# Service Bulletin

Bulletin No.: PI1133

**Subject:** Rear Compartment (Trunk) Water Leak

**Models:** 2014 Chevrolet Impala Built After April 22, 2013

3649621

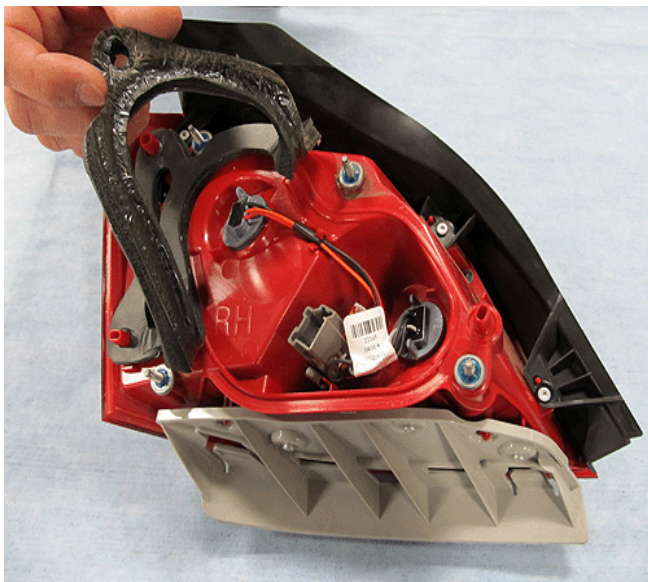
- 3.2. Slowly peel the seal away from the housing using care to remove the adhesive from the housing.  
**Tip:** Removing the seal at a 45° angle while slightly stretching the rubber will remove most of the adhesive with the seal.

3649624

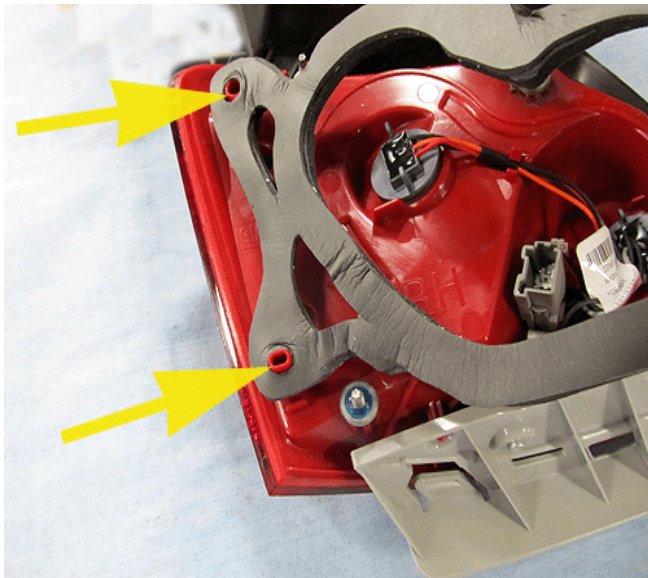
- 3.4. Ensure the adhesive side of the seal is facing the lamp. Start the new seal application by placing the two outer alignment pins through the holes on the seal.

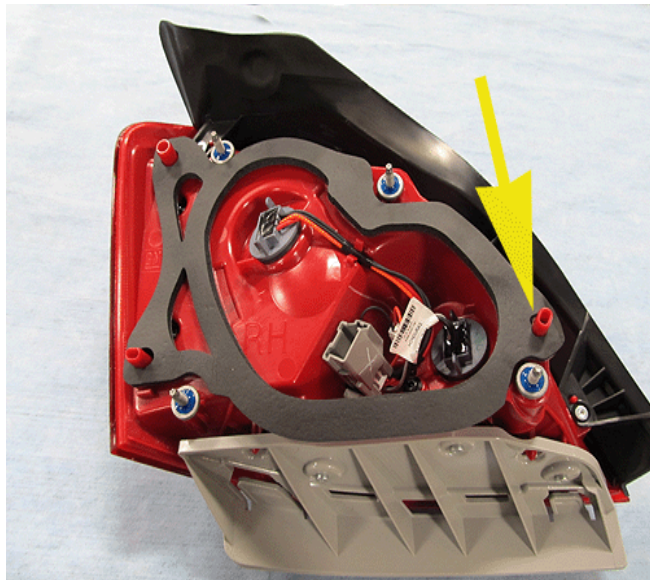
3.5. Install the seal, ensuring it is centered on the compression ribs on the lamp housing as shown.
